UNITED STATES PATENT AND TRADEMARK OFFICE

APPLICATION NO.	FILING DATE	FIRST NAMED INVENTOR	ATTORNEY DOCKET NO.	CONFIRMATION NO.
10/798,024	03/11/2004	Bo Li	KLA-P1362 US	5994
27652	7590	07/28/2006		EXAMINER
JOSHUA D. ISENBERG JDI PATENT 809 CORPORATE WAY FREMONT, CA 94539			CONNOLLY, PATRICK J	
			ART UNIT	PAPER NUMBER
			2877

Office Action Summary	Application No.	Applicant(s)
	10/798,024	LI, BO
	Examiner	Art Unit
	Patrick J. Connolly	2877

DETAILED ACTION

FIG. 2A

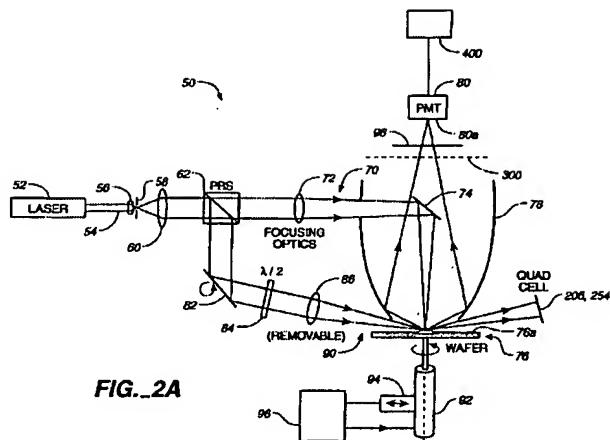
As to claim 36, '601 teaches a method for enhancing a signal to noise ration in a sample inspection system (see Figure 2a below) including:

in a sample inspection system of the type having collection optics including a collection optics (78) that receive radiation scattered from a point on a sample surface (76a) proximate a symmetry axis of the collection optics and direct the scattered radiation toward a detector (PMT 80), a method for enhancing a signal to noise ratio, the method comprising the steps of: collecting part of the scattered radiation with an imaging device (PMT 80); generating an image of the scattered radiation wherein a signal from defects on the surface is distinguishable from a background noise due to surface roughness; and in response to the image, selectively screening the detector from portions of the scattered radiation corresponding to the background noise (see columns 11 and 12, also Figures 9A-9F).

As to claim 38, '601 discloses a variable optical member comprising a liquid crystal display member (98, Figure 2A; see also Figures 10A, 10B, also column 11, lines 60-67 through column 12, lines 1-22).
